ALLEGATION RECEIPT REPORT

Subject: Millstone Unit 2 Inspection 91-18

SUBJECT: Millstone Unit No. 2
Evaluation of Pressure Gages for
PDCR-2-112-79.

FIGURE NO. 14

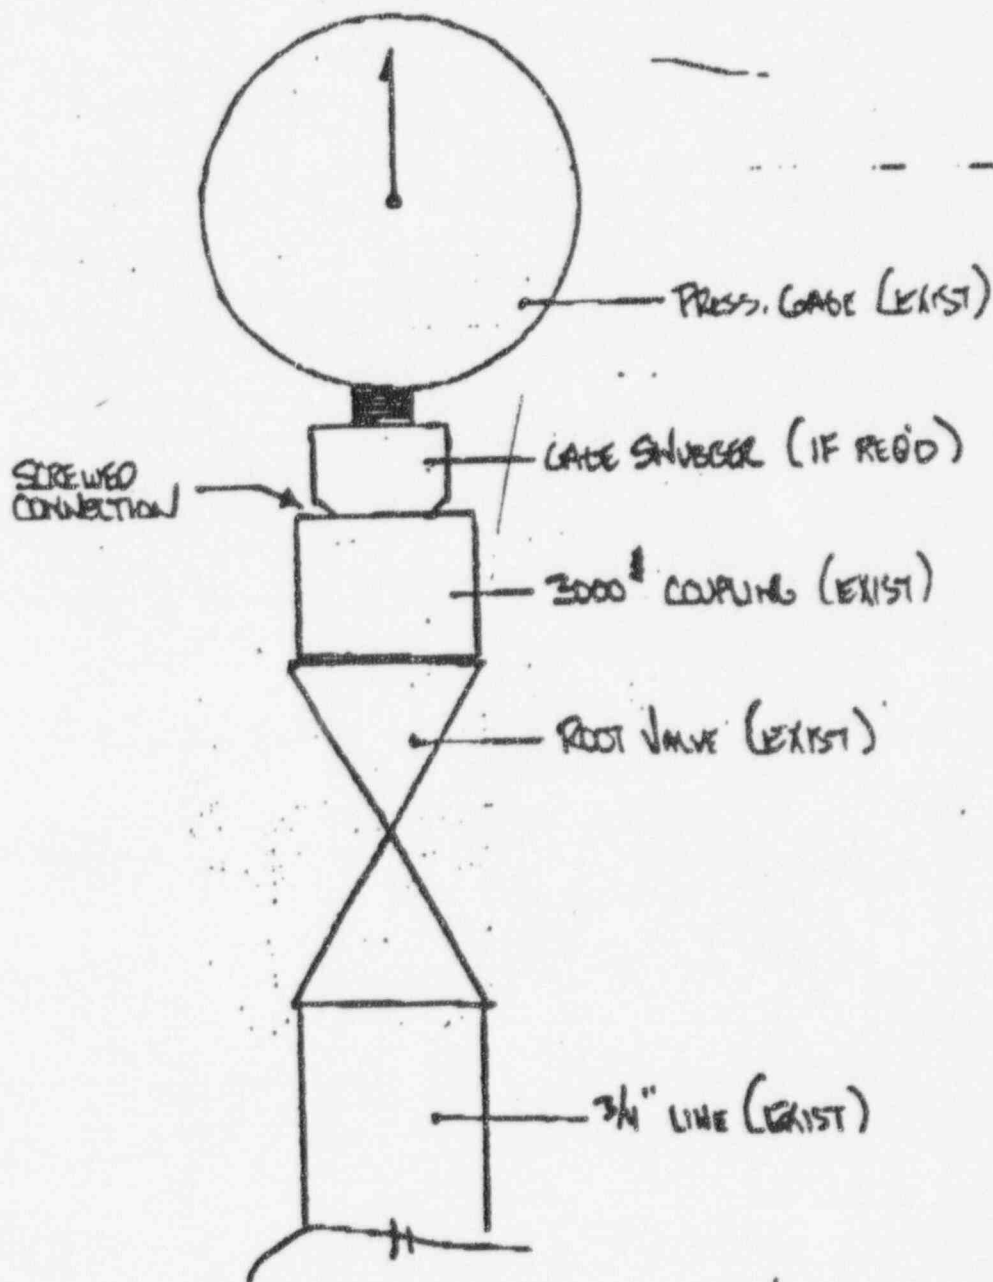
The pressure gages were installed under reference 1. The pressure gages were installed using several unnecessary fittings, couplings and valves. No apparent design criteria was used. The present configuration is not in accordance with established plant design criteria. However, by engineering judgement, a postulated DBE seismic event would not result in a structural failure that would compromise the integrity of the associated piping system. It is recommended that the present configurations be modified to ensure acceptable system stresses that meet the current design standards.

The pressure gage assemblies should be modified such that the gage and snubber fitting be assembled directly to the coupling fitting adjacent to the root valve. The attached Figure No. 14 shows the proposed typical configuration for all the pressure gages with the exception of PI 3053. The configuration of PI 3052 is shown on the attached Figure No. 15.

In summary, it is recommended that the pressure gages be modified according to Figures 14 and 15. The root piping and pressure gage fittings have been evaluated in the modified condition for all applicable load cases. All calculated stresses are within the Code allowable limits as defined in ASME III, 1974 Edition and are documented in reference 2.
